RE: REVISED GRADING & DRAINAGE PLAN OF RETAIL CENTER RECEIVED APRIL
24, 1987 FOR BUILDING PERMIT APPROVAL (K-23/D20)

RE: DRAINAGE PLAN FOR RETAIL CENTER
(K-23/D20) RECEIVED OCTOBER 29, 1986

RE: DRAINAGE PLAN FOR RETAIL CENTER
(K-23/D20) RECEIVED OCTOBER 29, 1986

PLOT & DRAINAGE PLANS

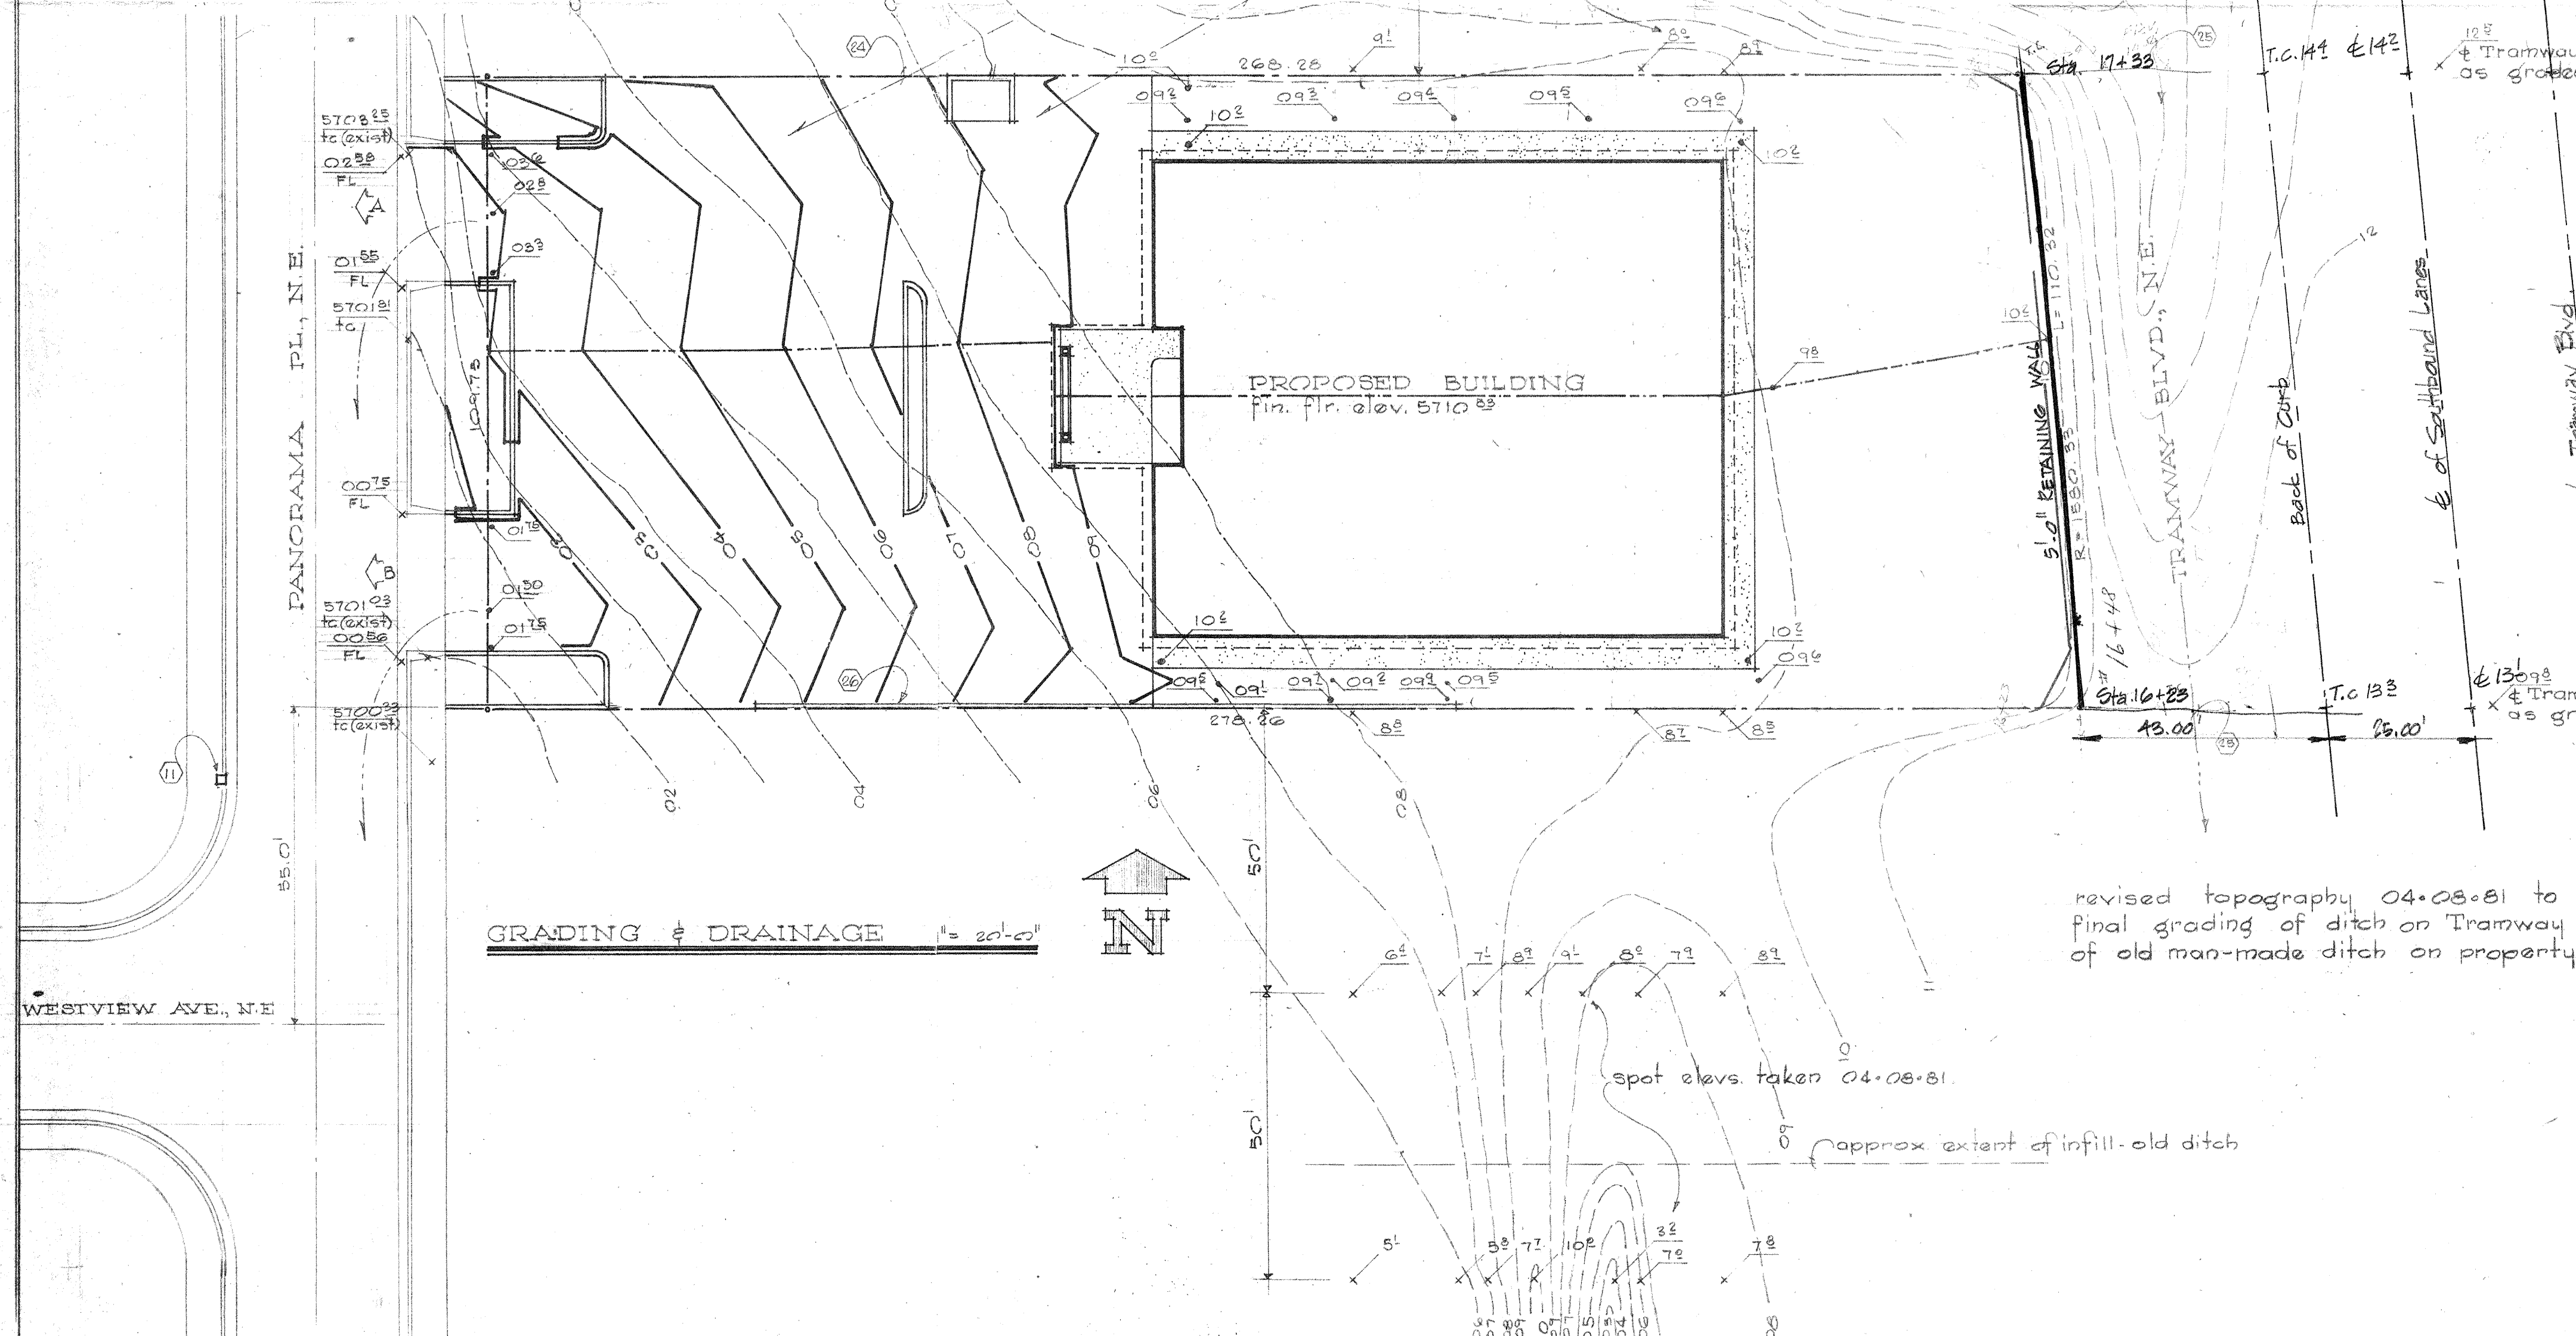
For the record, I would like to stress that information is lacking regarding the interfacing with the development to the south. The DPM specifically states that contours and or spot elevations shall extend a minimum of 25 feet beyond the property line. This plan does not comply with this requirement. However, in our discussion this date, you stated that the design matches the property to the south. I have no reason to doubt the integrity of your word. Therefore, I hereby grant approval for the subject request.

1. In future submittal, please identify your T.B.M. by either a curb notch or painted.
